AMENDMENT NO. 0001 TO ADVERTISED RFP DACW31-03-R-0008
EFFECTIVE: APRIL 23, 2003

LUKE C. MOORE ACADEMY HIGH SCHOOL

SHEET: M1.3

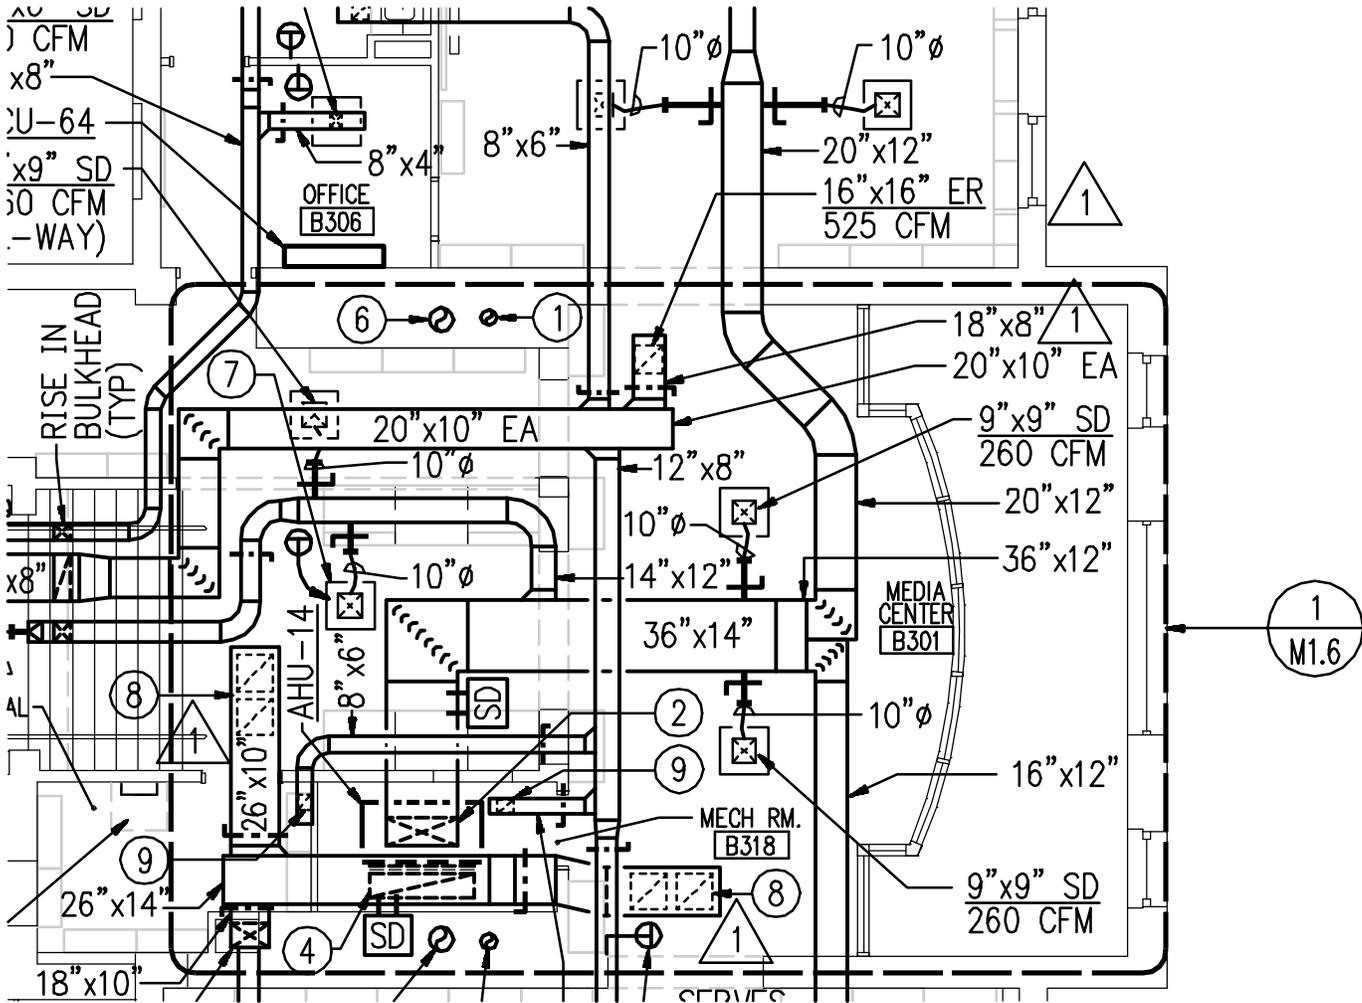
- 93) Sheet M1.1: Revise Sheet M1.1 in accordance with the attached sketches SK-M-1, SK-M-2, and SK-M-3 dated 4/17/03.
- 94) Sheet M1.3: Revise Sheet M1.3 in accordance with the attached sketch SK-M-4 dated 4/17/03.

SHEET: M1.6

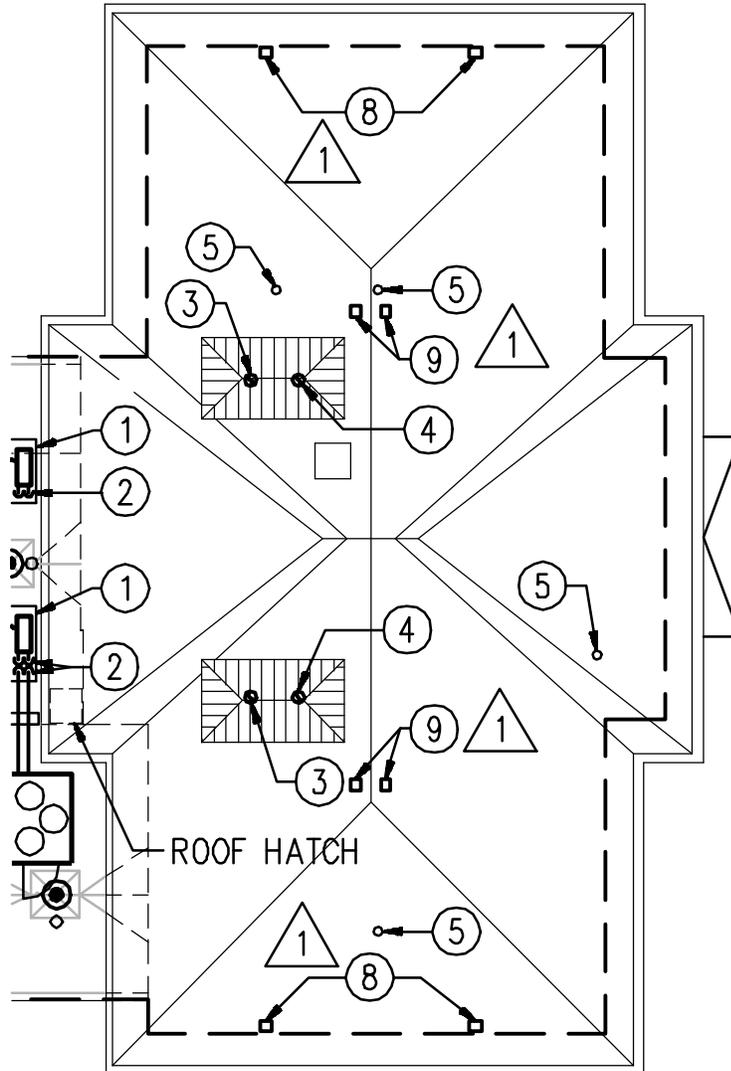
- 95) Sheet M1.5: Revise Sheet M1.5 in accordance with the attached sketch SK-M-5 dated 4/17/03.
- 96) Sheet M1.6: Revise Sheet M1.6 in accordance with the attached sketch SK-M-6 dated 4/17/03.

SHEET: M1.7

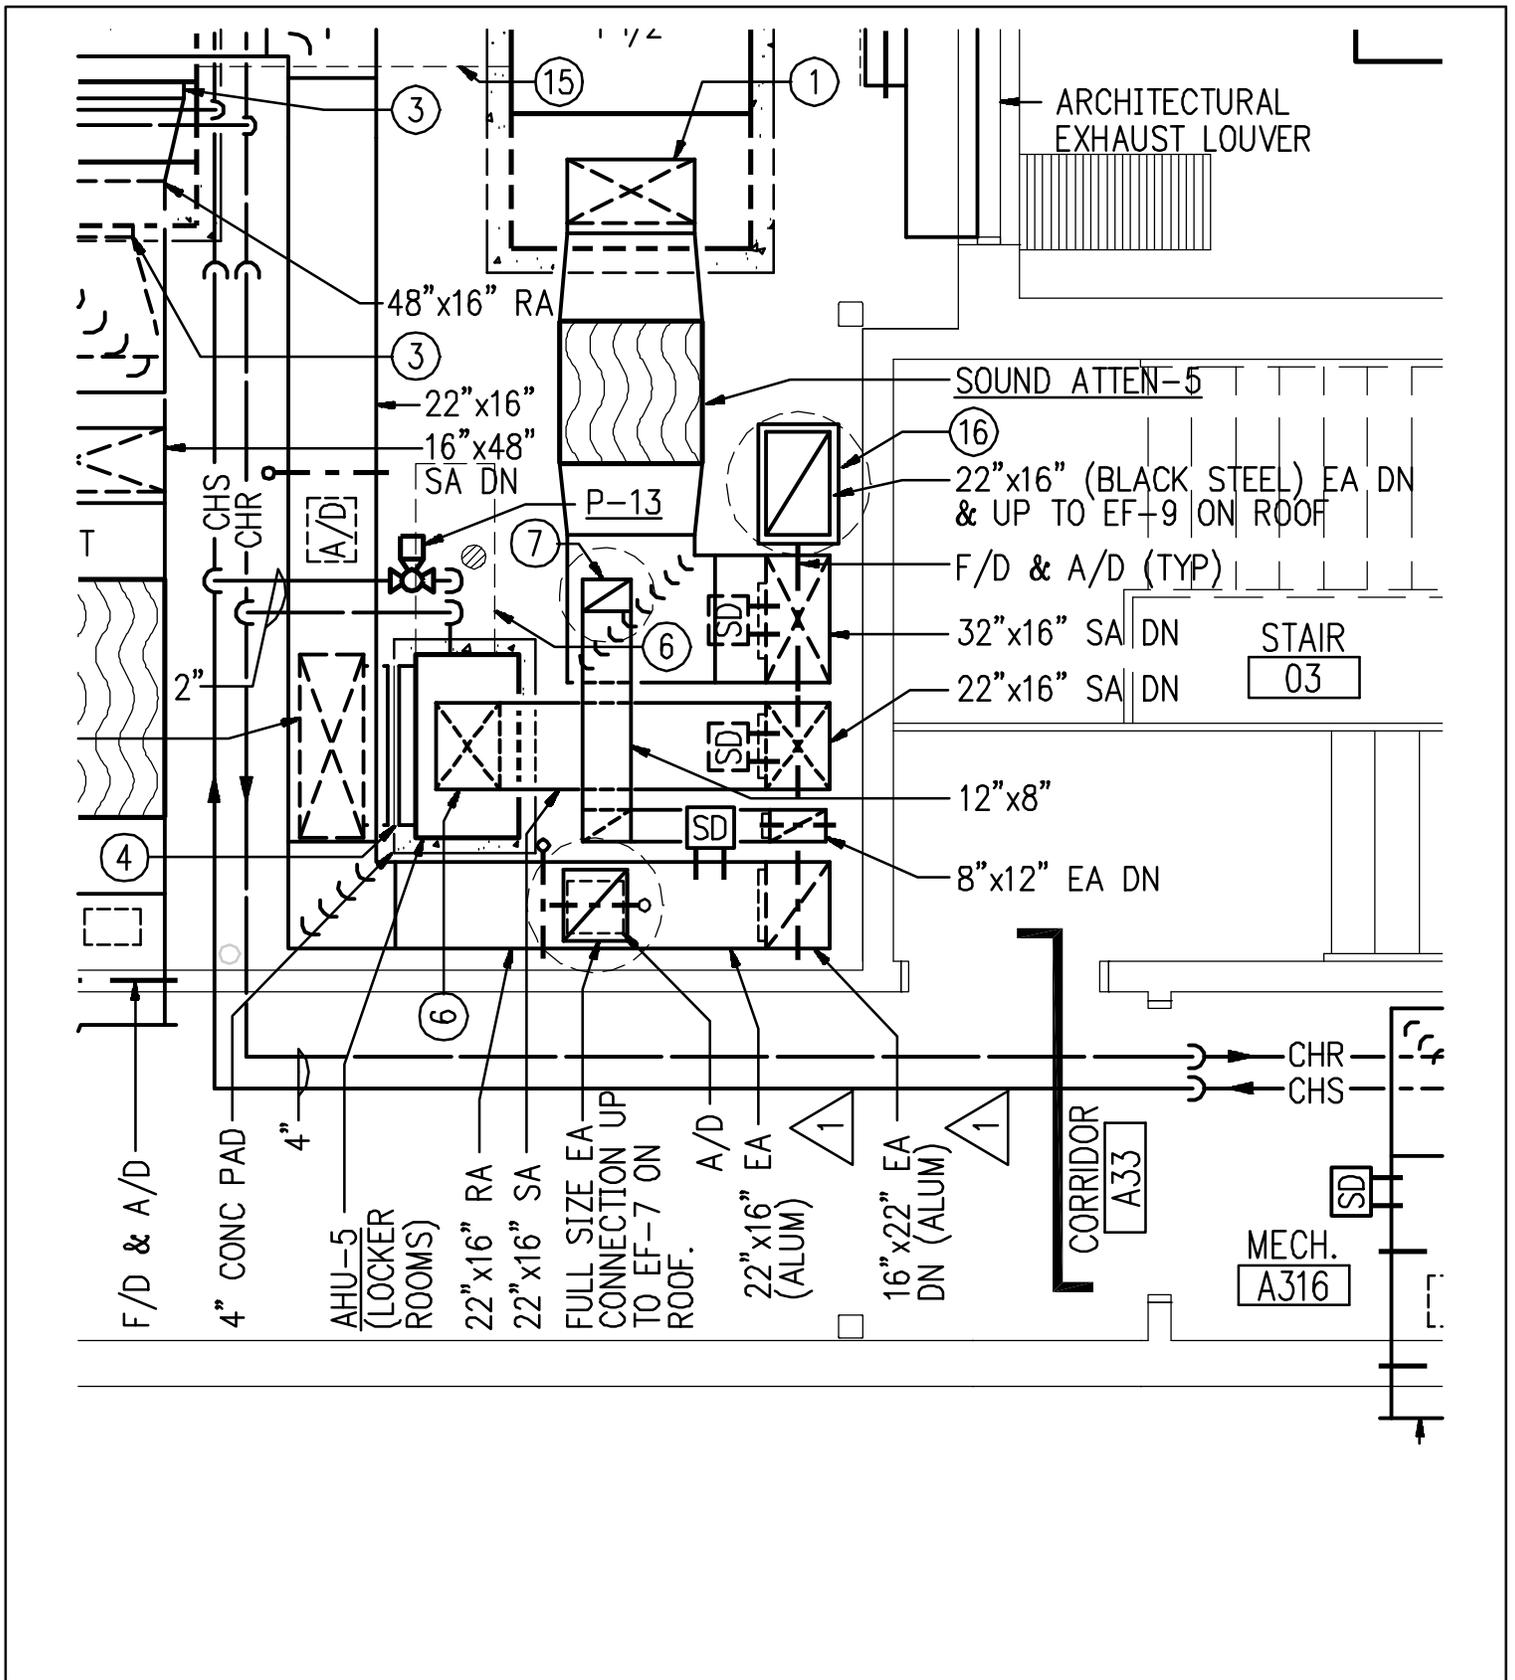
- 97) Sheet M1.7: Revise Sheet M1.7 in accordance with the attached sketch SK-M-7 dated 4/17/03.
- 98) Sheet M3.2: Revise Sheet M3.2 in accordance with the attached sketch SK-M-8 dated 4/17/03

SHEET: M3.3

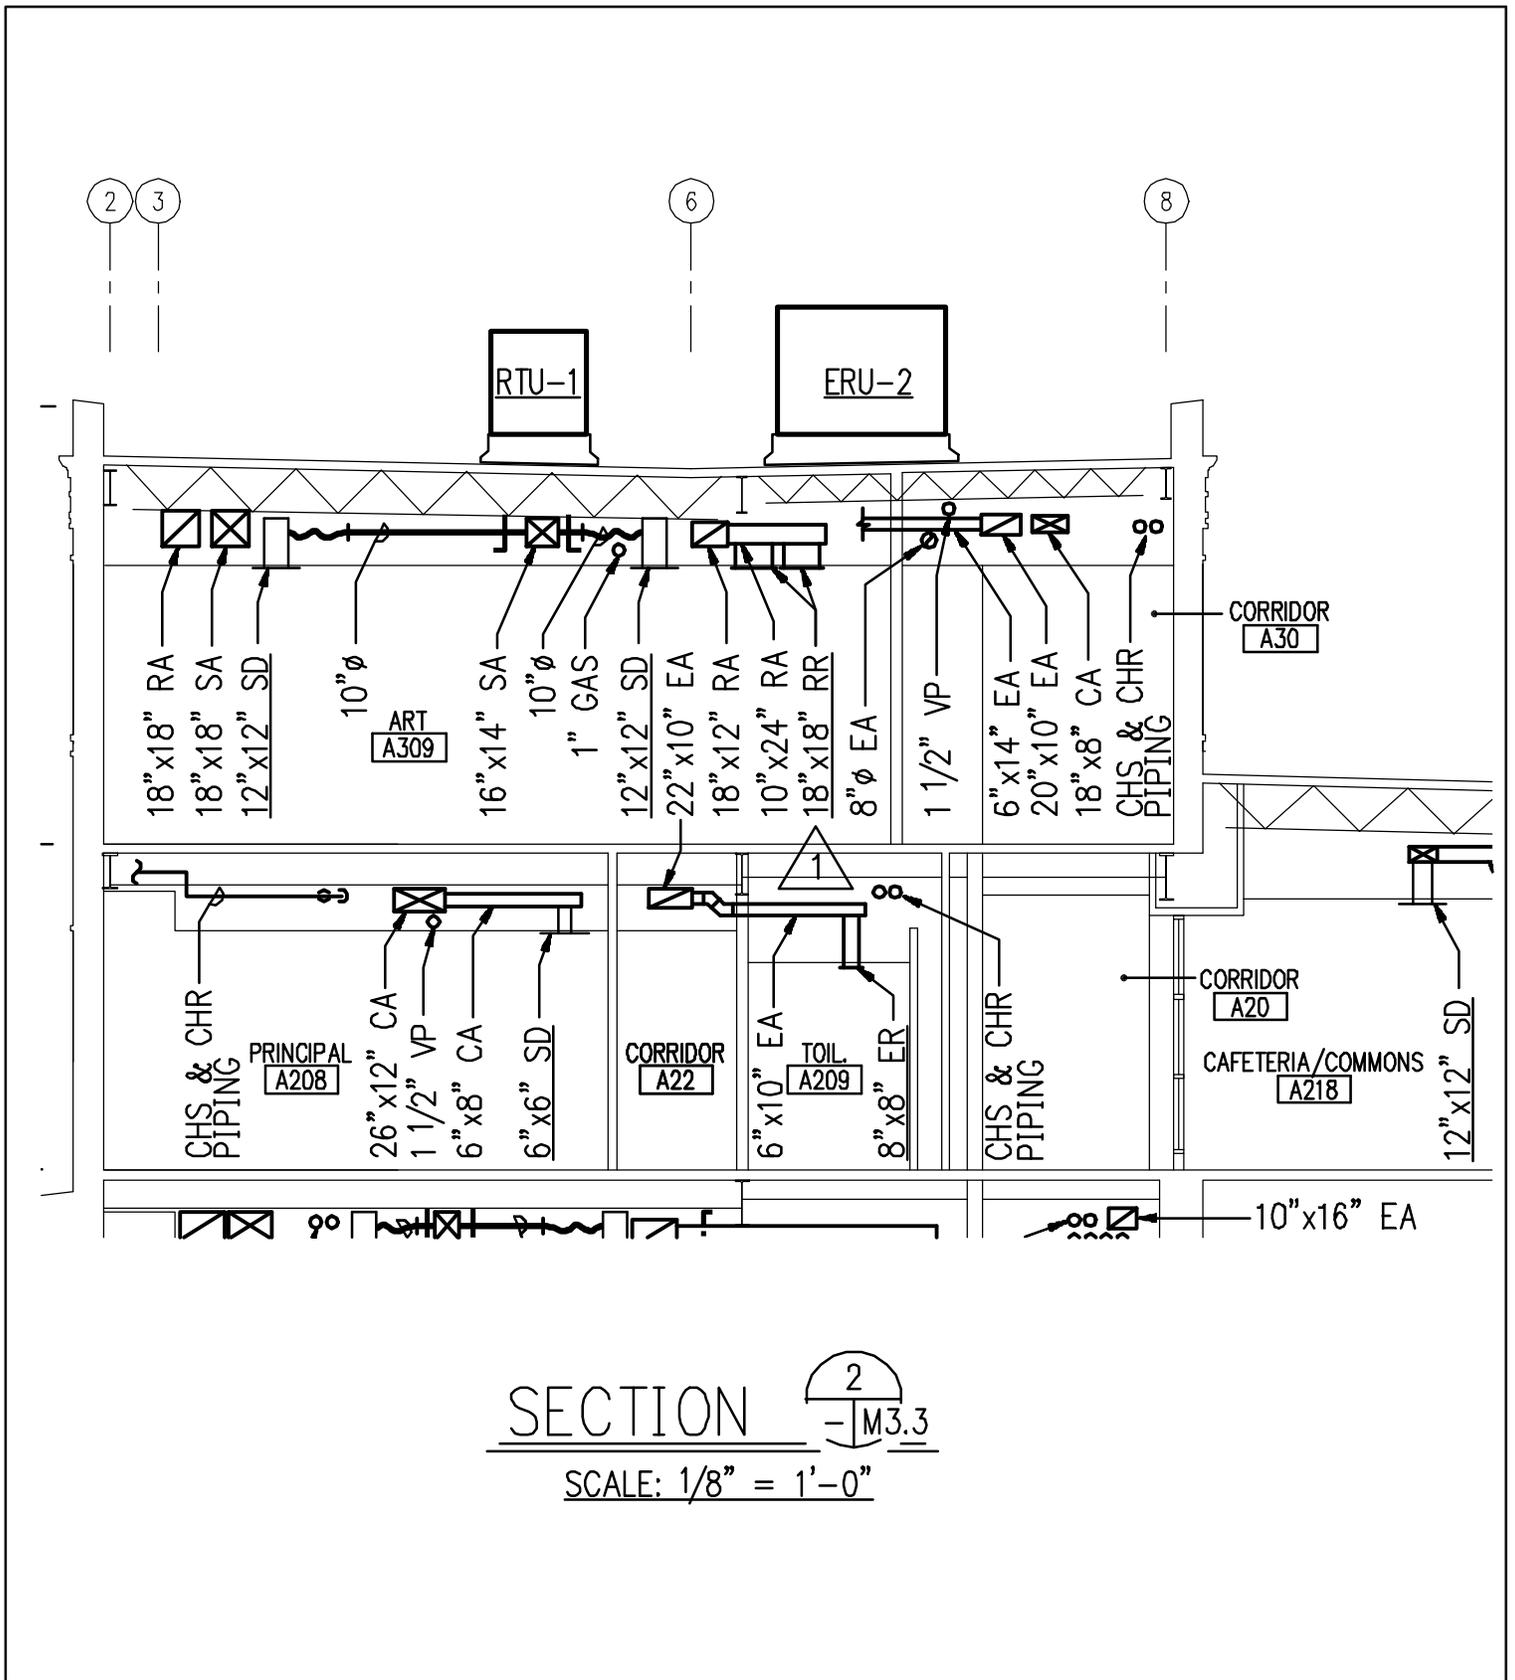
- 99) Sheet M3.3: Revise Sheet M3.3 in accordance with the attached sketches SK-M-9 and SK-M-10 dated 4/17/03.

9 SECTION @ MECH LOUVER @ CHILLER
 S-9.3 NOT TO SCALE

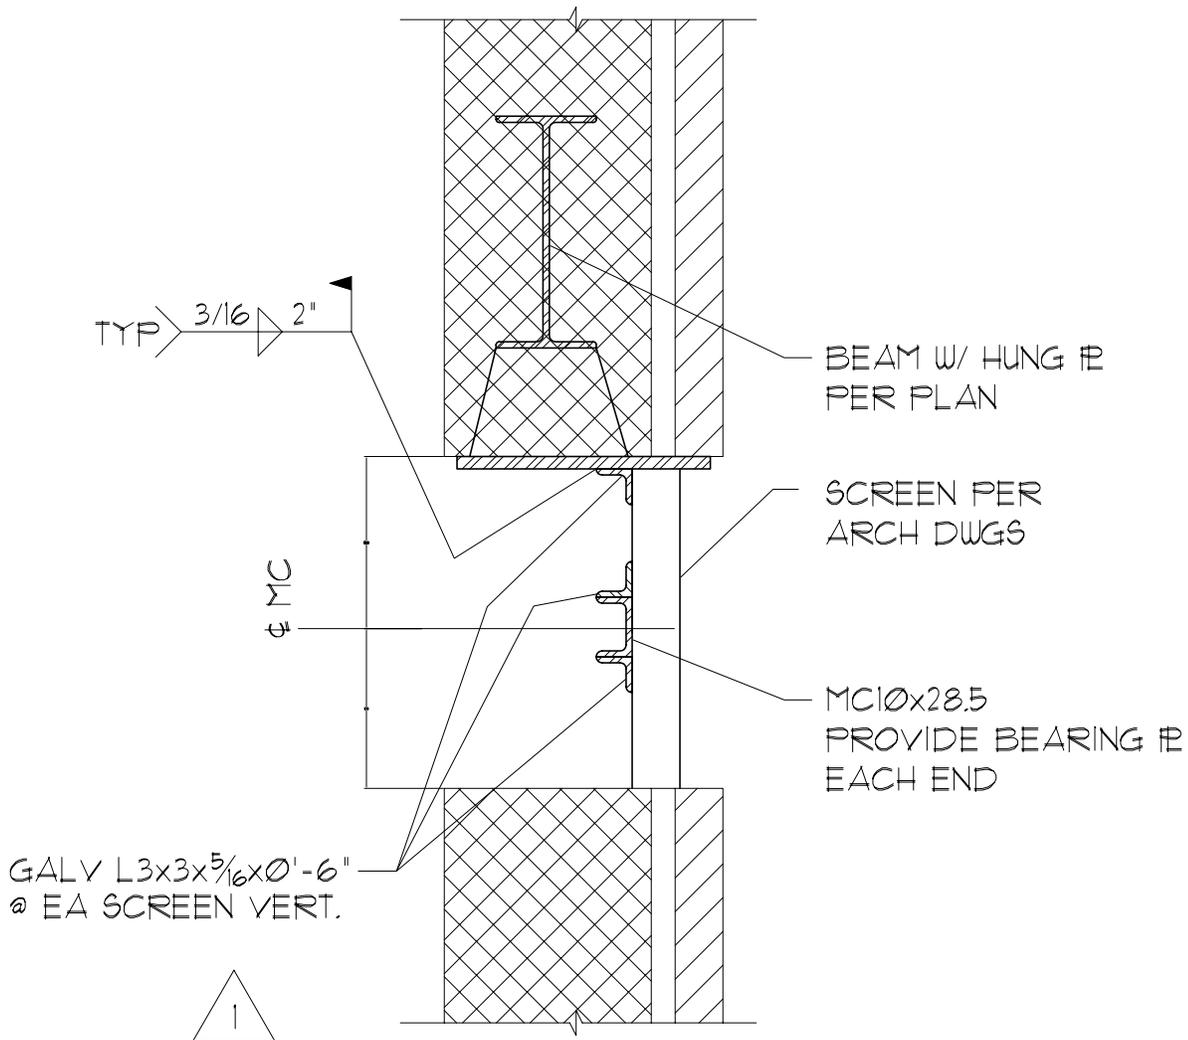
- 91) Sheet S-9.3: Add detail 9/S-9.3 per attached sketch SK-S-1, dated 04/17/03.
- 92) All Mechanical and Electrical Sheets: Substitute the words “optional bid” for the words “additive bid” wherever they appear.

SHEET NO: S-6.1

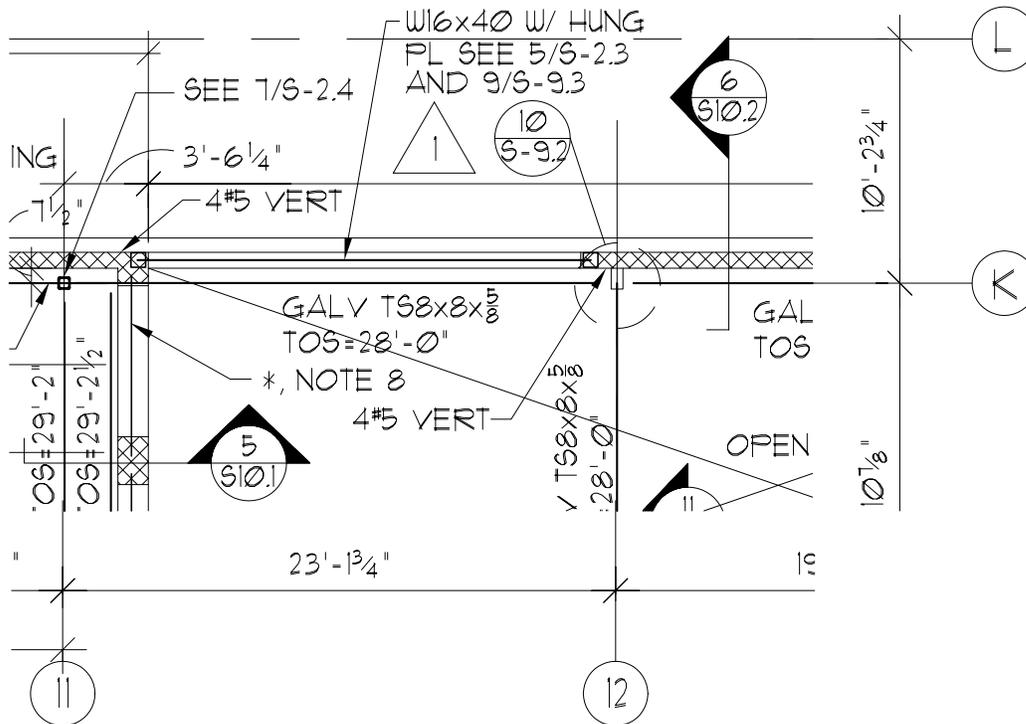
- 87) Sheet S-5.1: Revise per attached sketch SK-S-3, dated 04/17/03.
- 88) Sheet S-5.2: Revise per attached sketch SK-S-4, dated 04/17/03.
- 89) Sheet S-6.1: Revise per attached sketch SK-S-2, dated 04/17/03.
